Subject: Final Report - DER 82-42  
A 50.55(e) Reportable Condition Relating to Unit 1 Reactor  
Coolant Pump Pressure Tap Nozzle Weld Leak Due To Overheating  
Stainless Alloy  
File: 83-019-026; D.4.33.2

FINAL REPORT - DER 82-42  
DEFICIENCY EVALUATION 50.55(e)  
ARIZONA PUBLIC SERVICE COMPANY (APS)  
PVNGS UNITS 1, 2 & 3

Subject: Arizona Nuclear Power Project  
Units 1 and 2 Reactor Coolant  
Pump Pressure Nozzle Sensitization

CONTRACT NO.		CE-KSB PUMP CO. INC.
REVISED BY		HEWINGTON, N.H. 07837
DATE		
APPROVED BY		
SCALE 1/1		DO NOT SCALE DIMS
CE-KSB PUMP TYPE 101		ALTERATION OF DISCHARGE NOZZLE PRESSURE TAP
REVISED BY		SC-8000-00900
DATE		
APPROVED BY		
SCALE 1/1		DO NOT SCALE DIMS

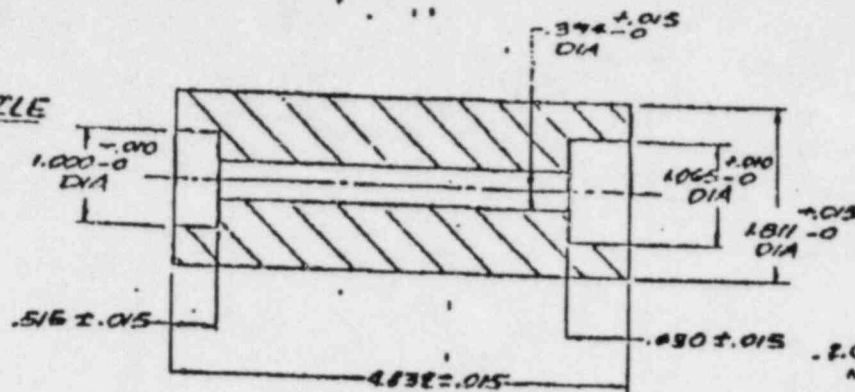
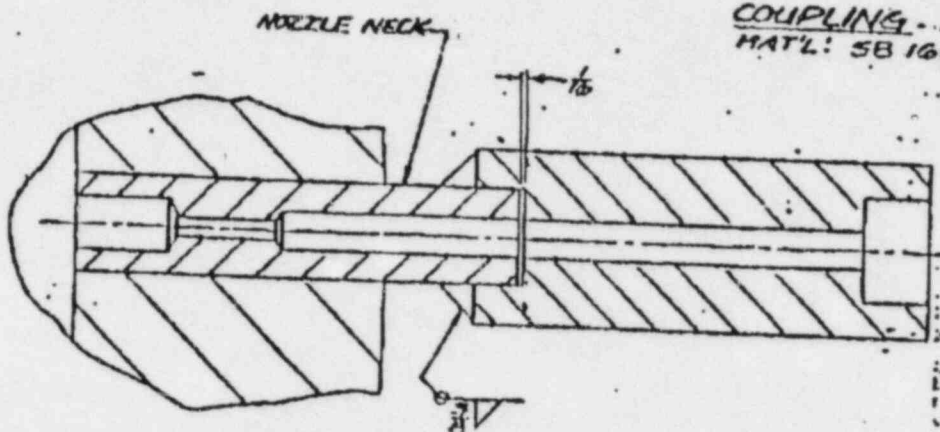
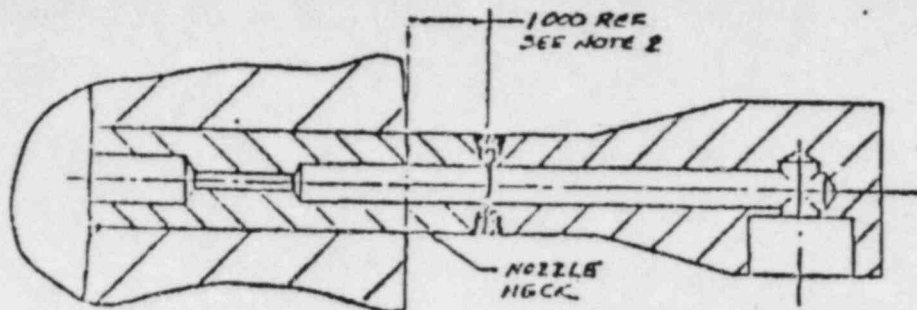
1. Remove the 316 stainless steel portion of the nozzle, the weld and as much as 1/4" of the inconel portion as possible. Return the removed portion to C-E since it is intended that the HAZ of the inconel be inspected at C-E Windsor. However, there is concern that access to the replacement fillet weld shown on Enclosure (1) might be overly restrictive. An optimum cutting elevation should be selected and its affect on the overall length of the replacement nozzle evaluated versus the field connected pressure piping. For Unit 1, replacement pressure nozzles have been fabricated to the Enclosure (1) dimensions.

CUTOFF FOR DISCHARGE NOZZLE  
PRESSURE TAP

COUPLING - SEE NOTE 1  
MAT'L: SB 166

1. L.P. C'BORE & MACHINED O.D. PER NB-2551 (3) OF THE ASME BCPV CODE 1974 EDITION, NO ADDENDA
2. CUT PRESSURE TAP TO LENGTH REQUIRED TO MAINTAIN INTERFERENCE OF FIELD PIPING.

INSTALLATION OF COUPLING  
TO NOZZLE NECK PIN 8000-207-002

DRAWING BY: [Signature]		CHECKED BY: [Signature]		DATE: 11-15-78	
SCALE: 1/16" = 1"		DO NOT SCALE DIMS.		CE-KSB PUMP CO. INC. NEWINGTON, N.H. 03891	
CE-KSB PUMP TYPE BCP		ALTERATION OF SUCTION NOZZLE PRESSURE TAP			
PART NO.:		SC-8000-0099		00

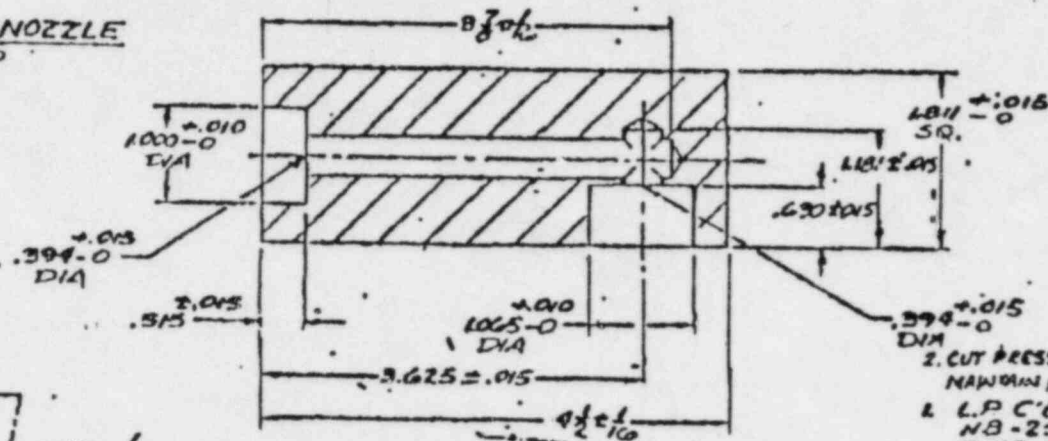
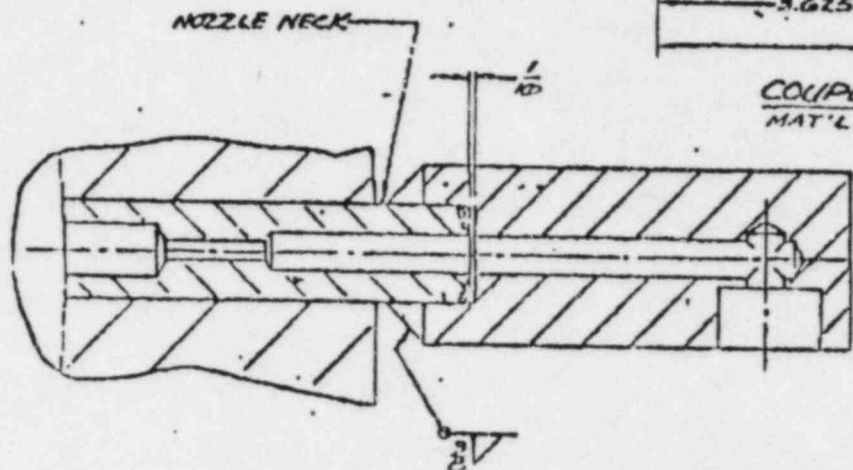
1. Enclosure (2) depicts the removal of the stainless steel portion at about the centerline of the weld. This location of cut was assumed to be optimum for two reasons:

- a. There would be sufficient access to make the fillet weld.
- b. Dressing the stub OD so that it fit into the  $1.000^{+0.010}_0$  socket would be a reasonable task.

If dressing the OD of the shop stainless steel-inconel weld is easier than anticipated, the location of cut could be raised slightly. For Unit 1, there replacement suction pressure nozzles have been fabricated to the Enclosure (2) dimensions.

CUTOFF FOR SUCTION NOZZLE  
PRESSURE TAP

2. CUT PRESSURE TAP TO LENGTH REQUIRED TO  
MAINTAIN INTERFACE OF FIELD PIPINGS.  
3. L.P. C'BORE & MACHINED O.D. PER  
NB-2551 (3) OF THE ASME 3B PV.  
CODE 1974 EDITION, NO ADDENDA.

INSTALLATION OF COUPLING  
TO NOZZLE NECK P/N 8000-214-002
